# Maule Aircraft Corporation

## SERVICE BULLETIN #6

**SUBJECT:** Auxiliary Gas Tank Vent Line Check Valve.

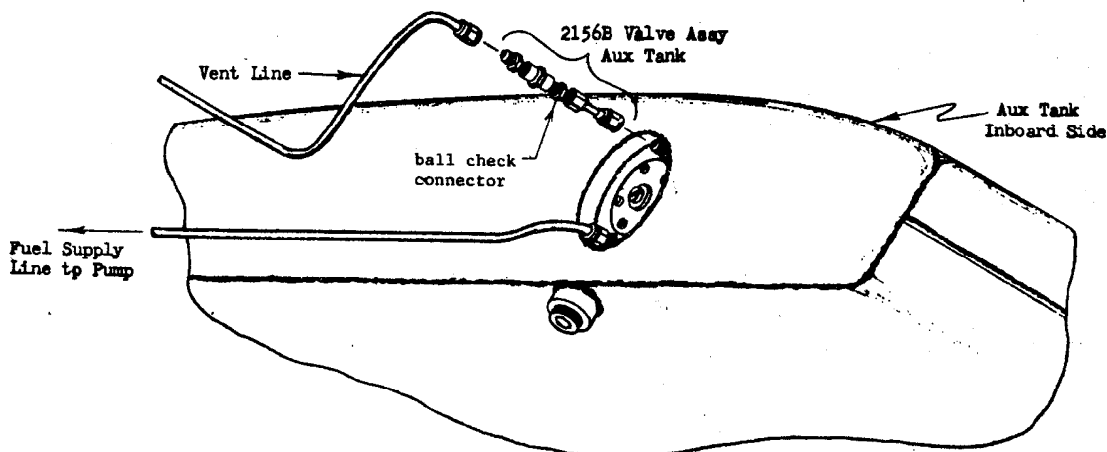
**BACKGROUND:** There is a possibility that the spring in the ball check connector in the check valve assembly is incorrectly positioned causing valve to be ineffective in properly venting tank.

1. Check for proper venting of left and right auxiliary fuel tanks by the following procedure:
  - a. Remove Auxiliary Fuel Tank cap.
  - b. Place 1/4" I.D. hose over aft 1/4" vent line below wing (3/8" line is main tank vent). Ascertain hose has covered small hole in vent line located just under wing skin.
  - c. Blow air through hose. If air passes freely through valve to tank, valve is alright and no further inspection of valve is necessary.
2. If air passage is blocked, correct by the following procedure:
  - a. Remove ball check connector shown in sketch:

- b. Remove retainer screw, ball and spring. Reverse spring and reassemble as shown in sketch below:

- c. Set punch (2 places) after setting retainer flush with ball check connector housing end as shown below:
- 
- d. Reinstall ball check connector in same position in valve assembly.
- e. Check for proper installation by repeating procedure in 1.b.
3. If Auxiliary tanks are equipped with Stant caps identified by "S" impressed on the top side in center of caps, remove nylon inserts from Center of gas caps by drilling (#30) through inserts from underside but not through top plate of caps. Be sure all nylon particles are removed before replacing caps to tanks. This procedure results in vented caps.
4. Add statement to the Aircraft Log Book pertaining to compliance with this Service Bulletin #6. Also, fill out the enclosed compliance record sheet and return to Maule Aircraft Corporation as soon as possible.
